SUNDRY NOTICES AND REPORTS ON WELLS (DO NOT USE THIS FORM FOR PROPOSALS TO DRILL OR TO DEEPEN OR PLUG BACK TO A DIFFERENT RESERVOIR. USE "APPLICATION FOR PERMIT" (FORM C-101) FOR SUCH PROPOSALS.)		WELL API NO. 30-025-09563

2. Name of Operator GRIZZLY OPERATING, LLC		6. State Oil & Gas Lease No.
3. Address of Operator 5847 SAN FELIPE, STE. 3000, HOUSTON, TEXAS, 77057		7. Lease Name or Unit Agreement Name TOBY

LEASE/WELL: **TOBY #1**

# PROPOSED P&A

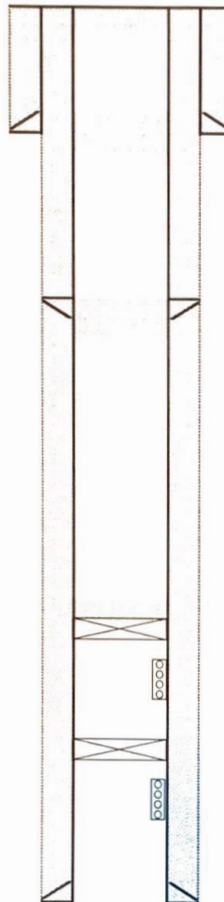
PERF @ 100' & CIRC CMT TO SURF VIA 5-1/2" X 8-5/8" CSG ANN  
**Perf 200' circ to surf**

**Spot 25 sx Class C on existing CIBP**
